DATE	REVISION
STATE OF HAWAII DEPARTMENT OF TRANSPORTATION HIGHWAYS DIVISION INDEX TO DRAWINGS, ABBREVIATIONS, SUMMARY OF ESTIMATED QUANTITIES HAWAII BELT ROAD KUPAPAPULUA BRIDGE WIDENING HAMAKUA DISTRICT Federal Aid Project No. BR-019-2(38) Scale: As Noted Date: June 23, 2003

SHEET No. S-1 OF 36 SHEETS

PARTIAL ABUTMENT PLAN/SECTION
SHOWING REVISED REINF. AT CORNER COL.

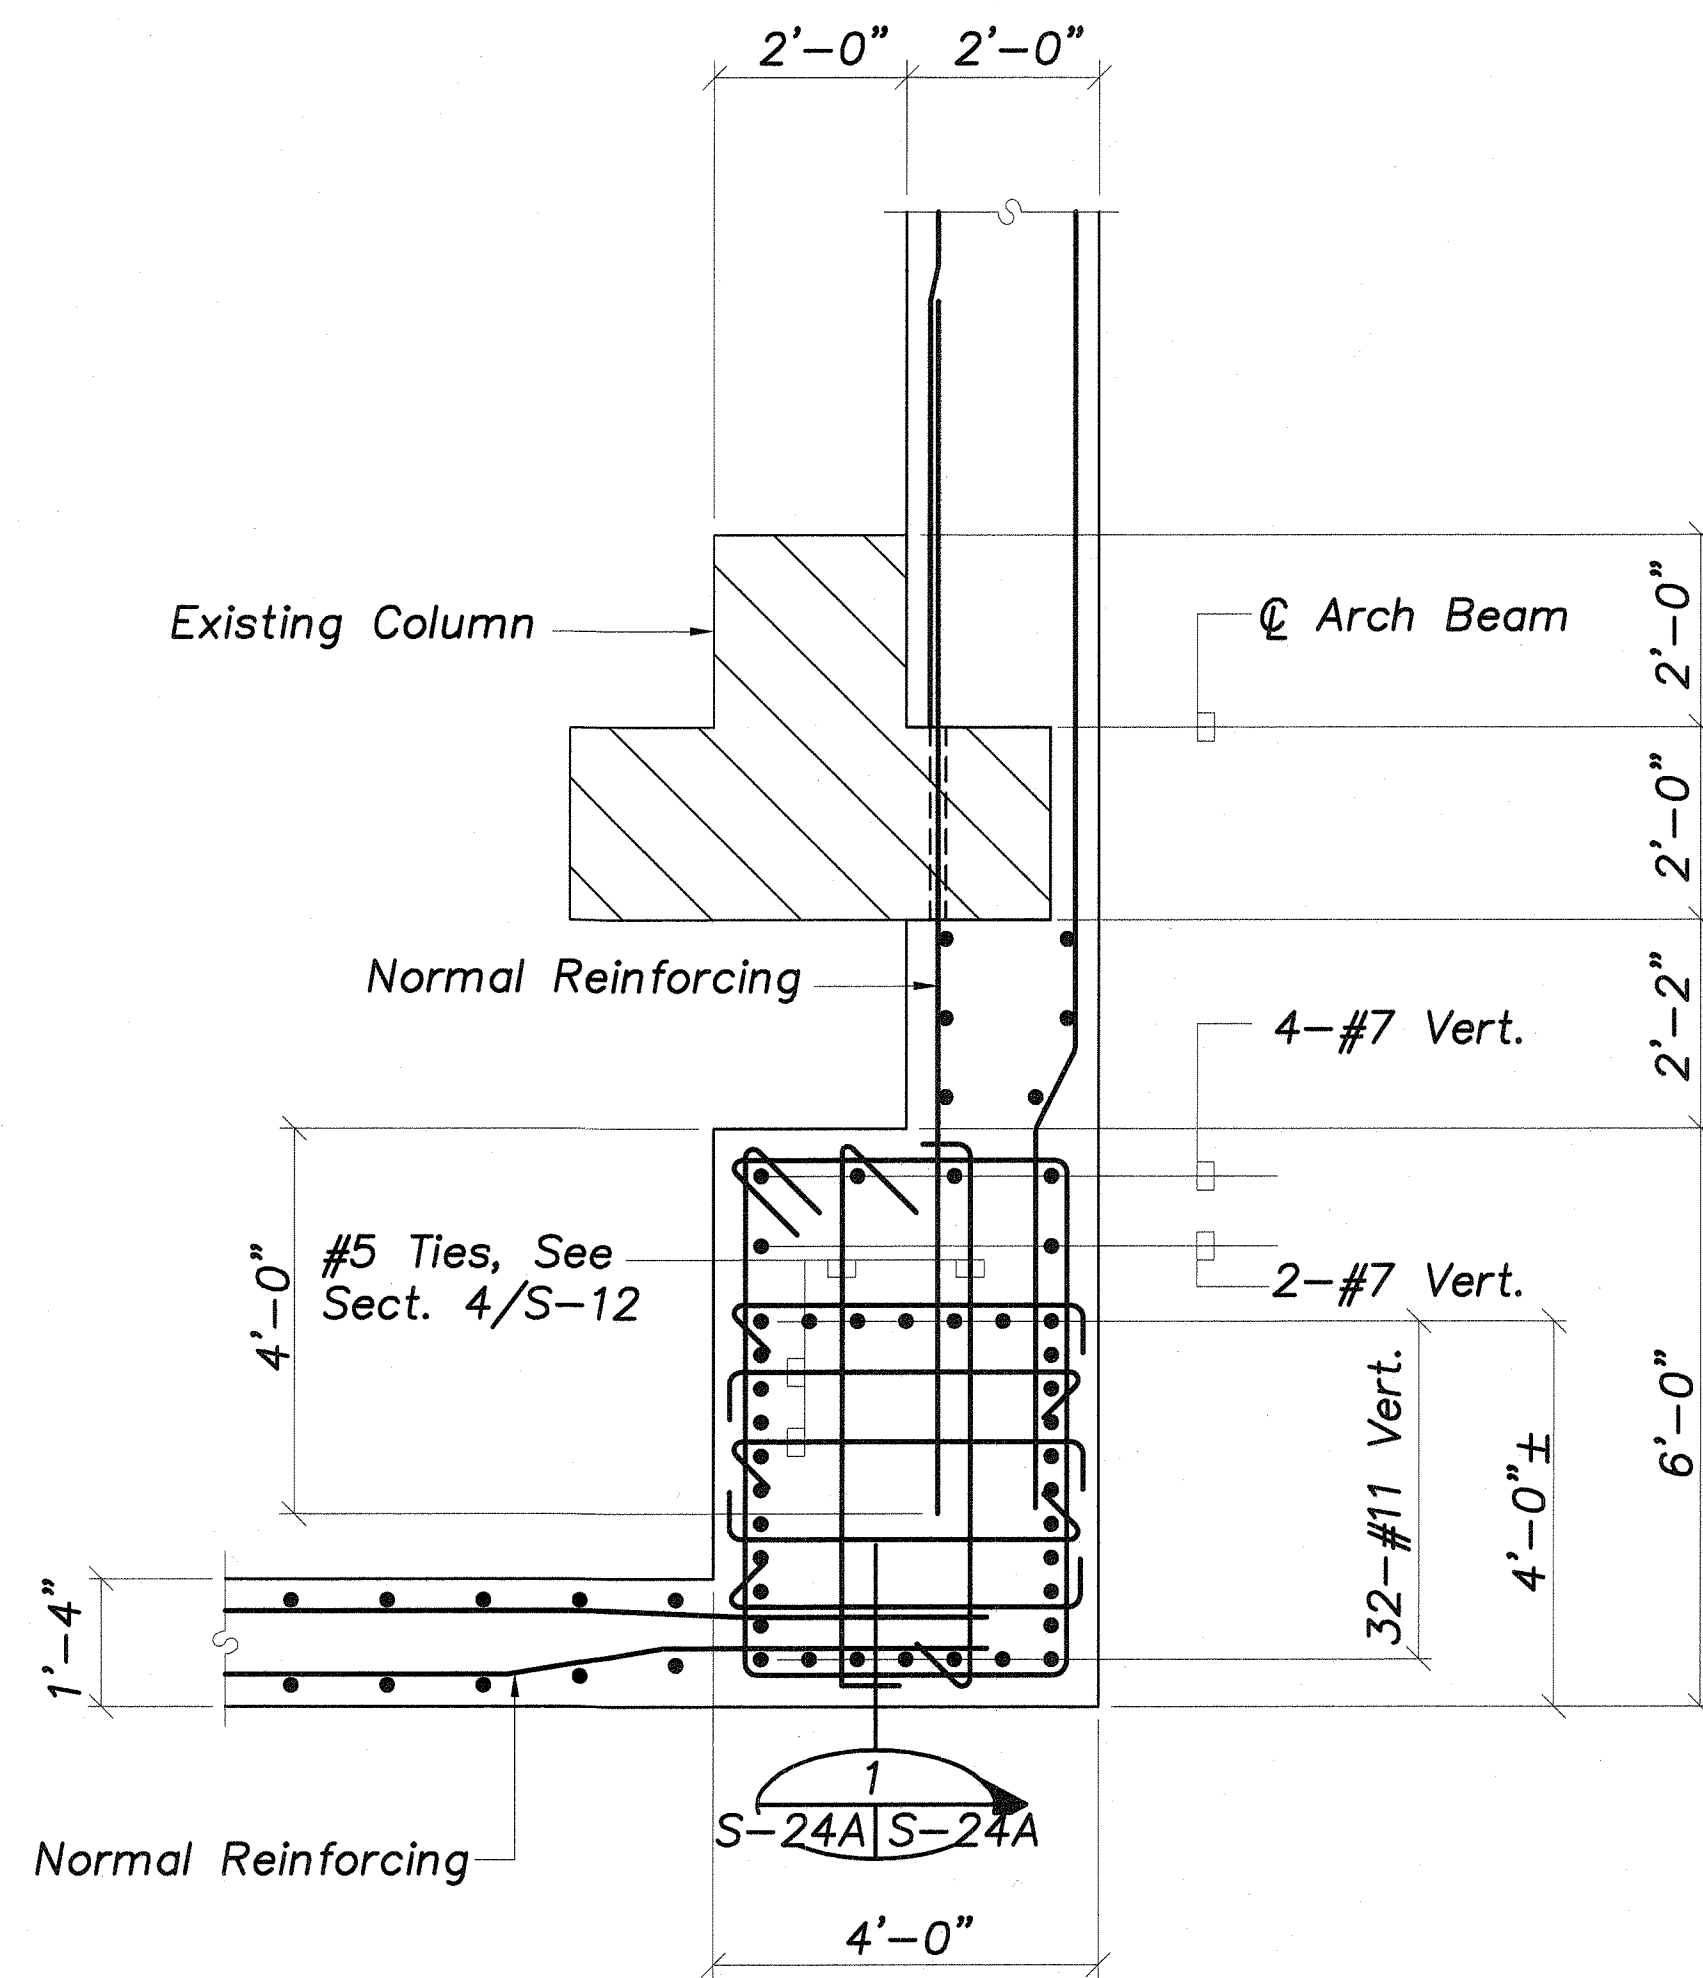
PARTIAL ABUTMENT SECTION AT
CORNER COLUMN REVISED REINFORCING

REVISED SERVICE STAIRS TOP LEVEL LANDING
 Scale: 1/2"=1'-0"
 (At Abutment No. 1)

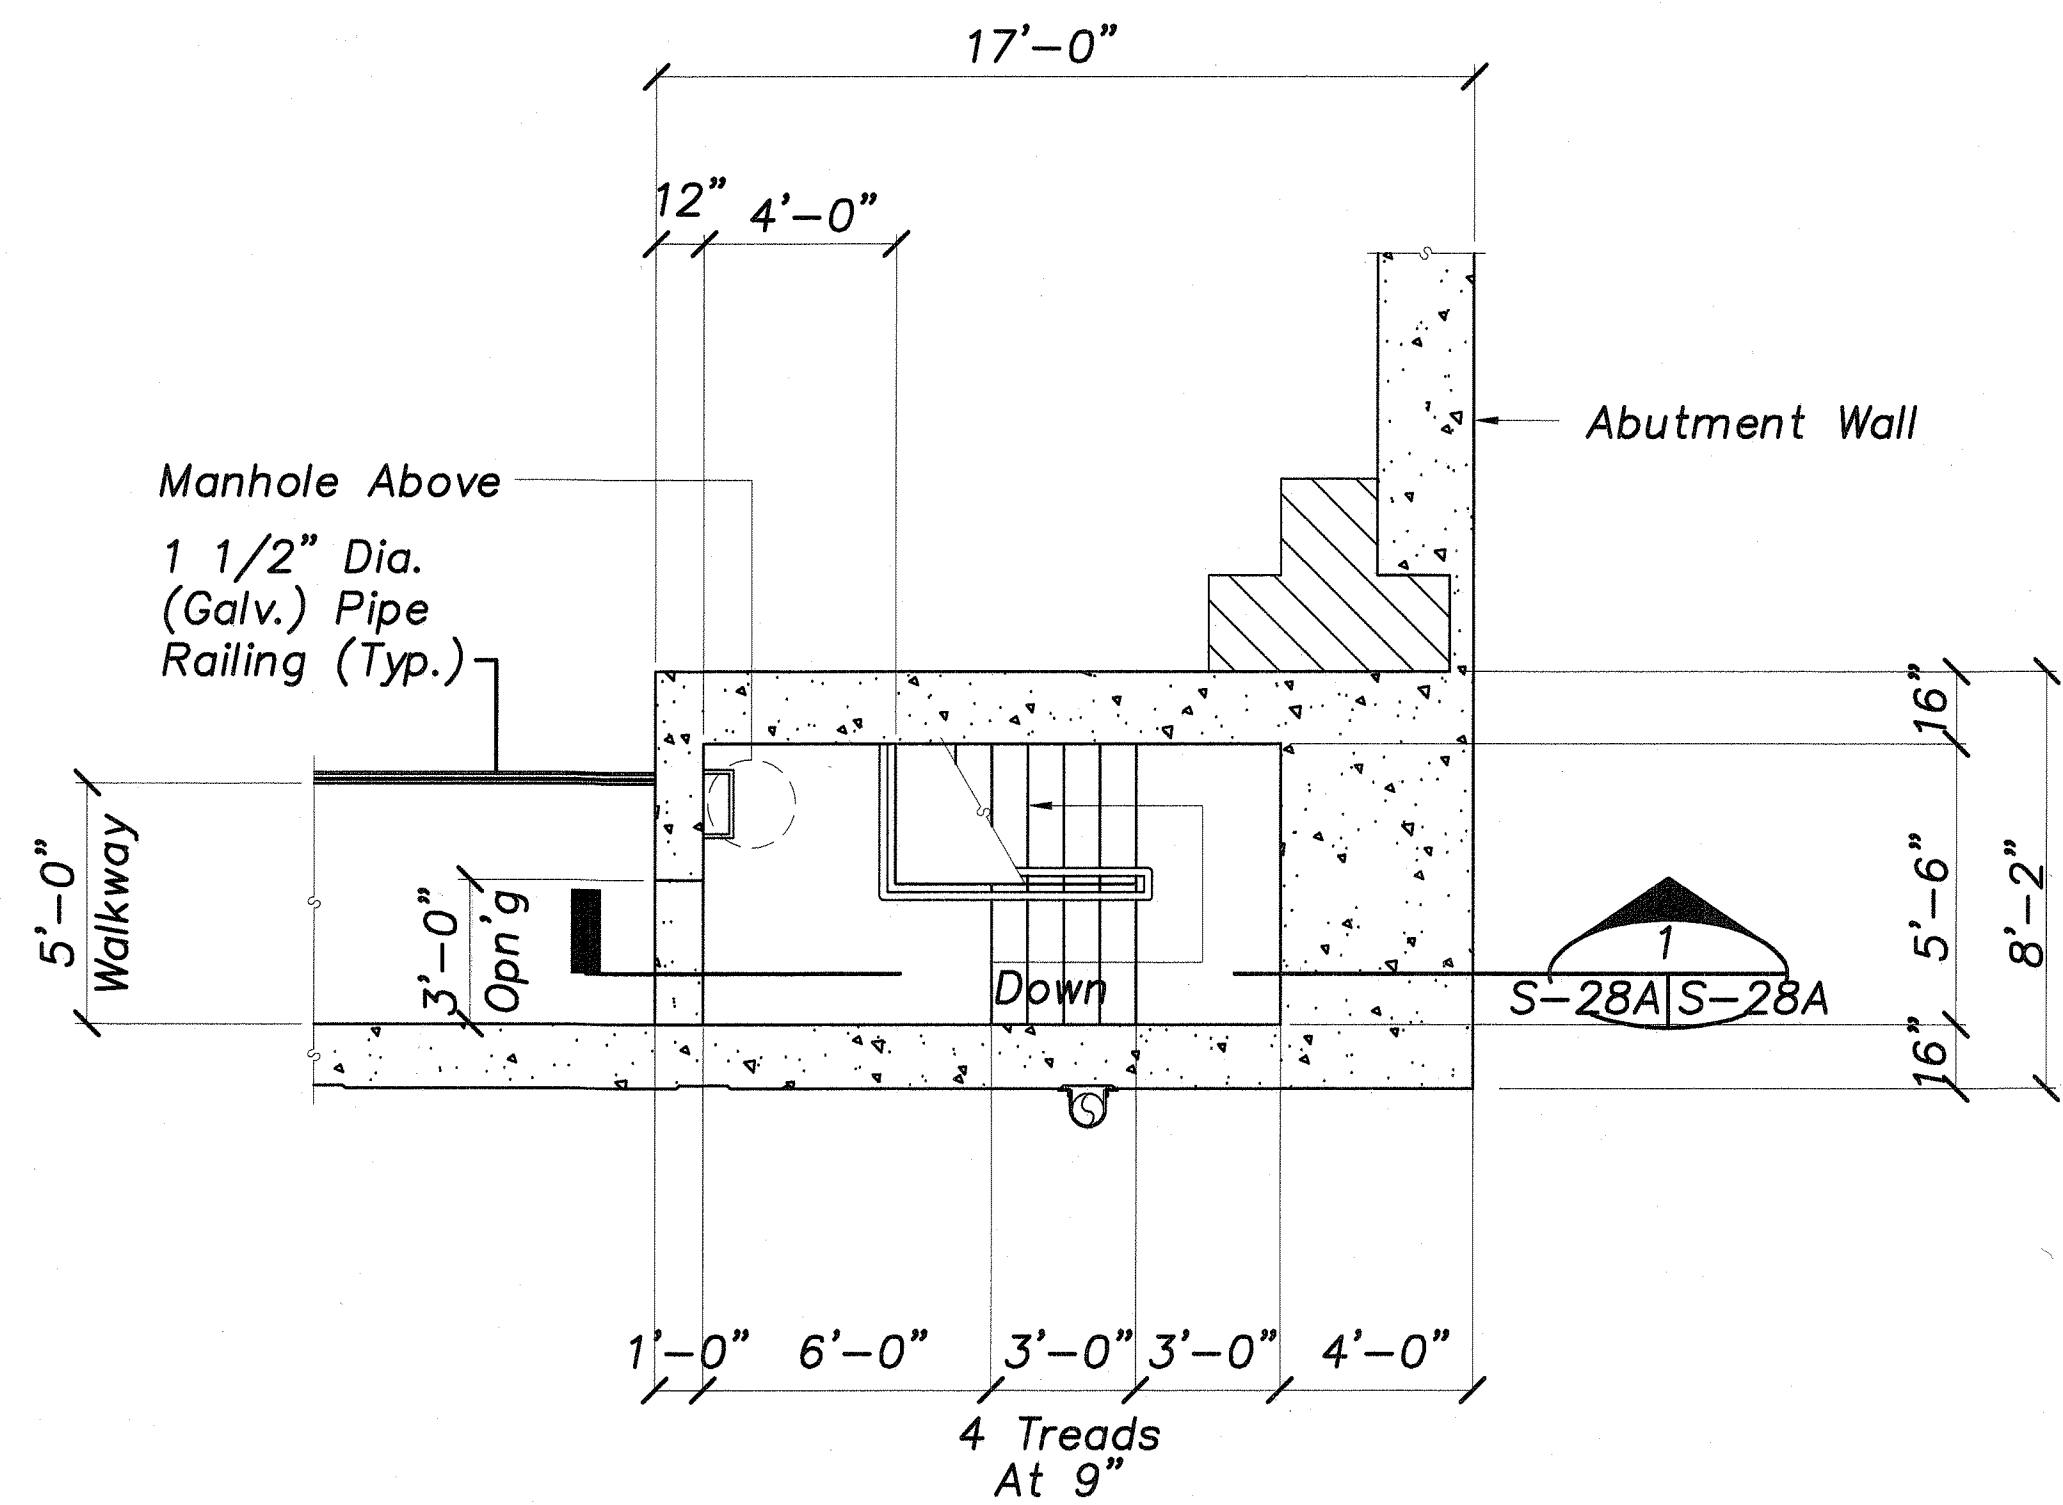
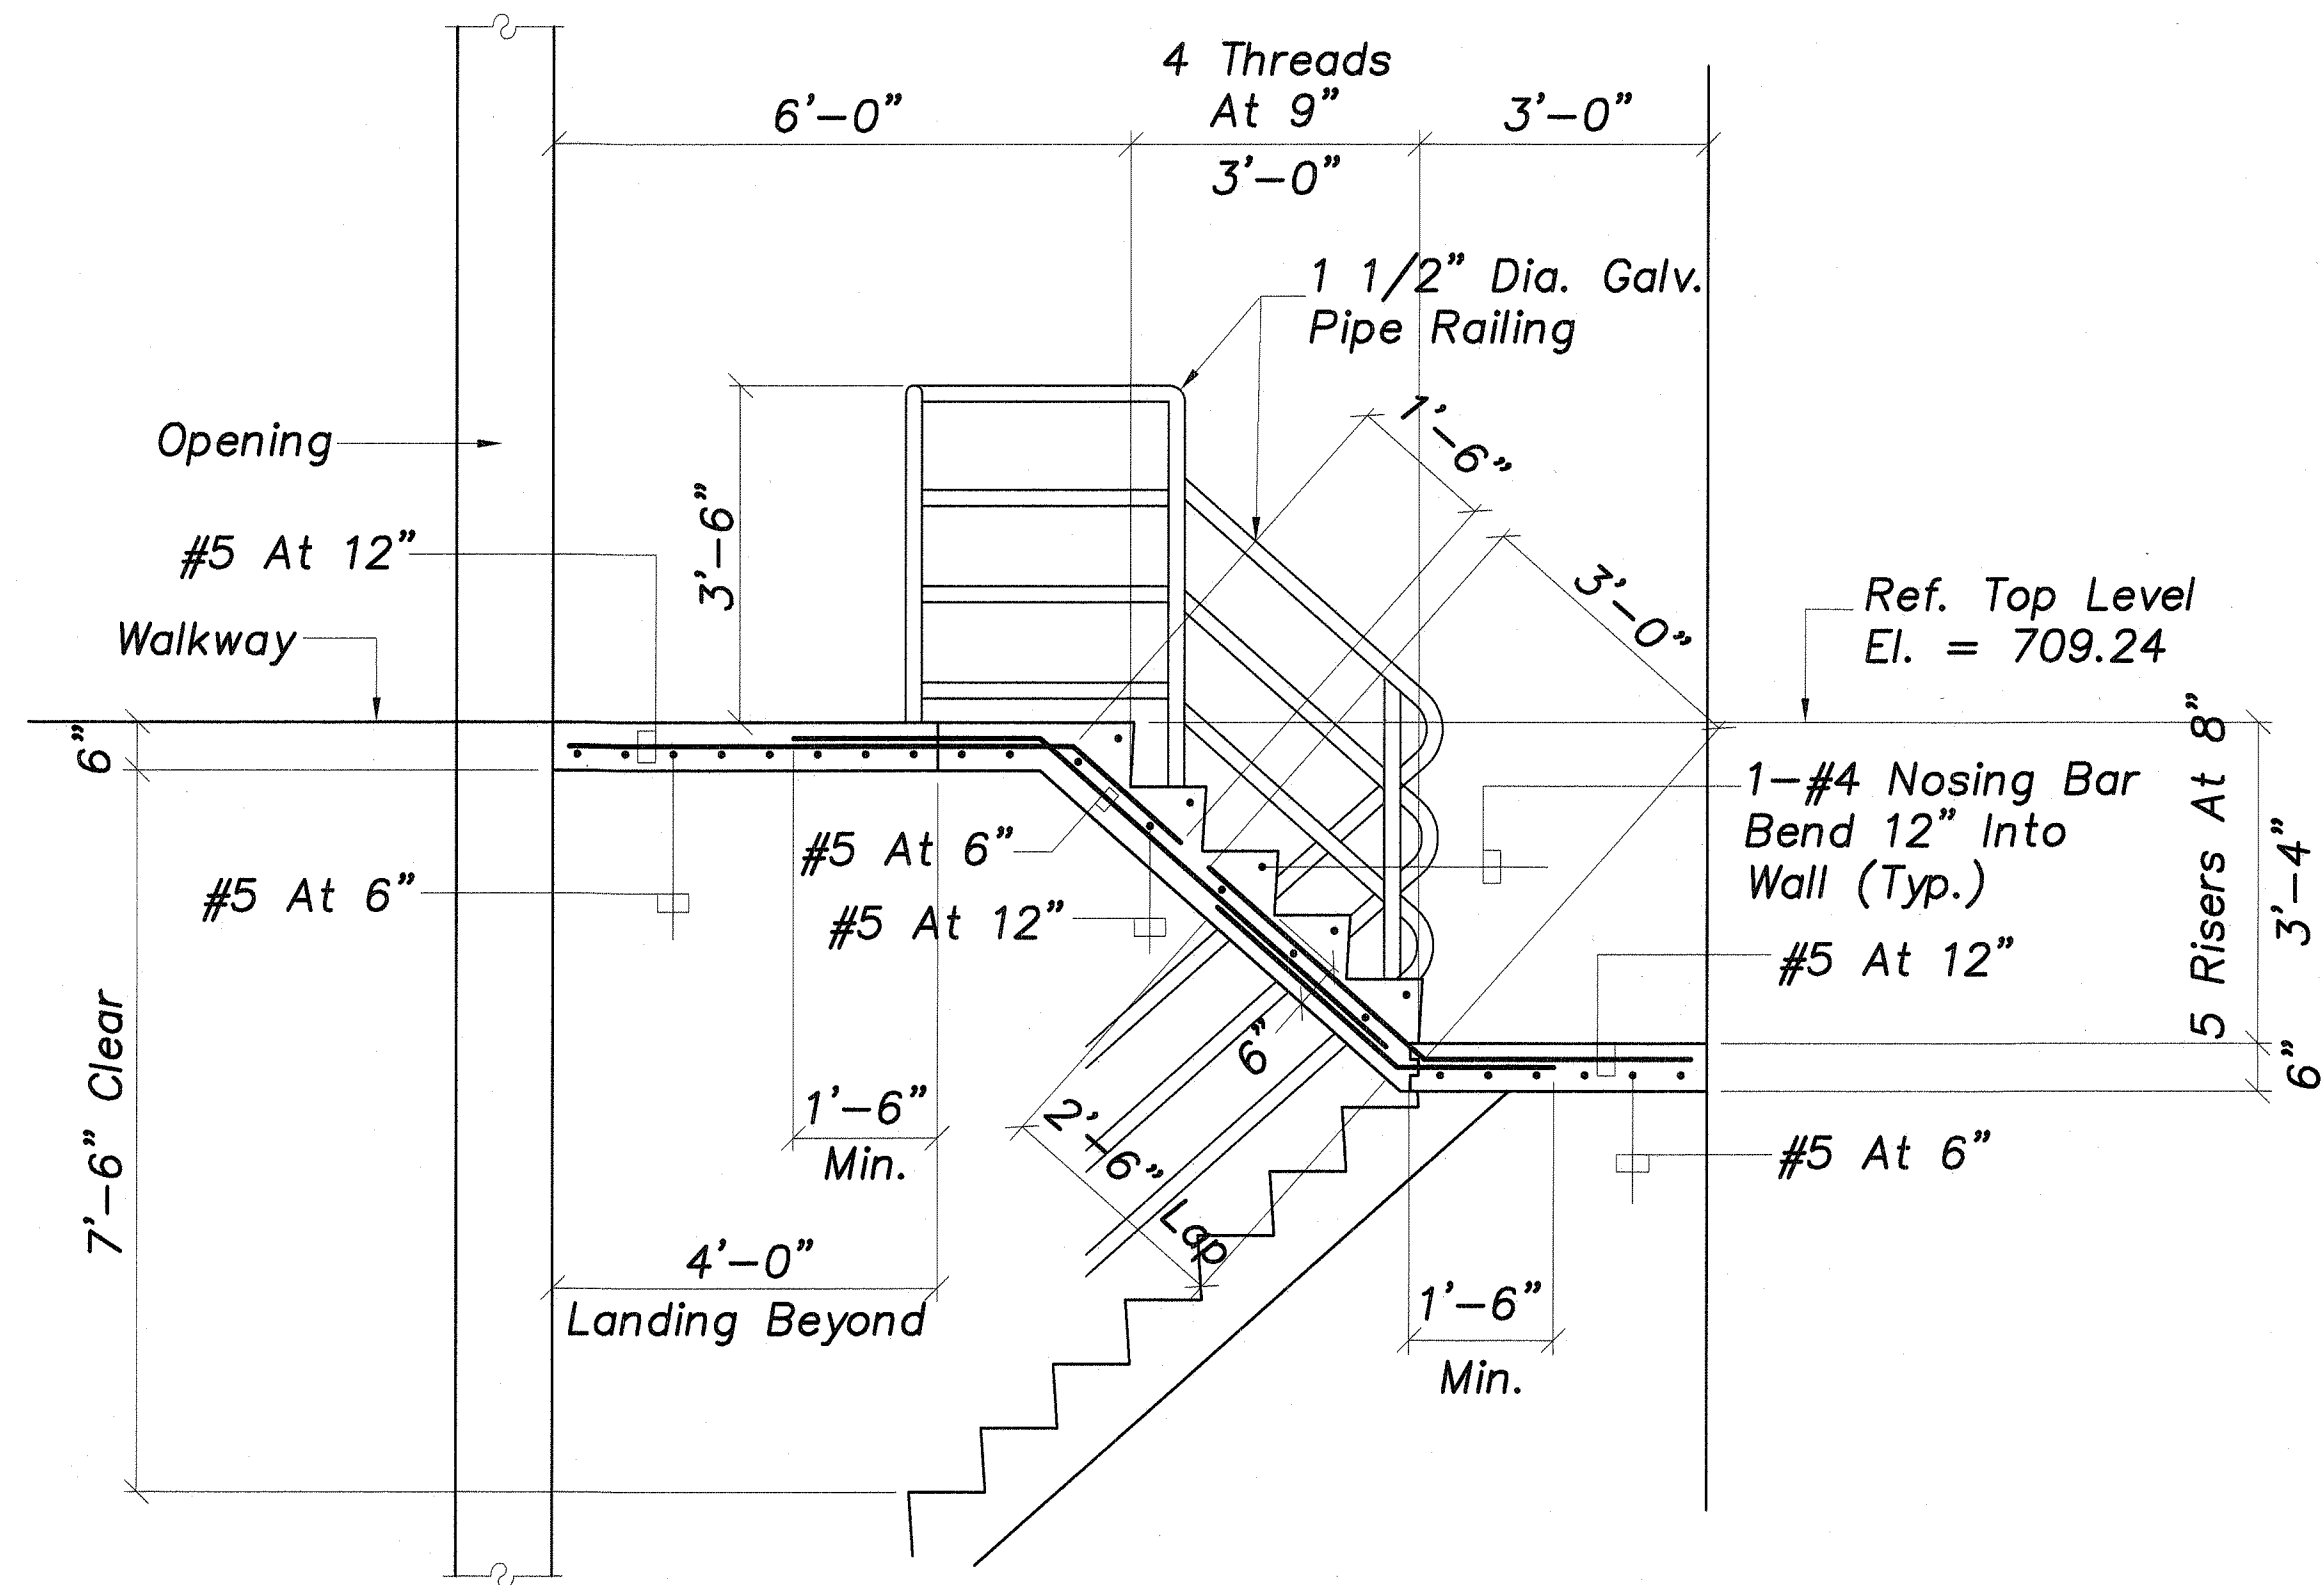
Note:
 This Tracing Prepared During
 "As-Built" Posting.
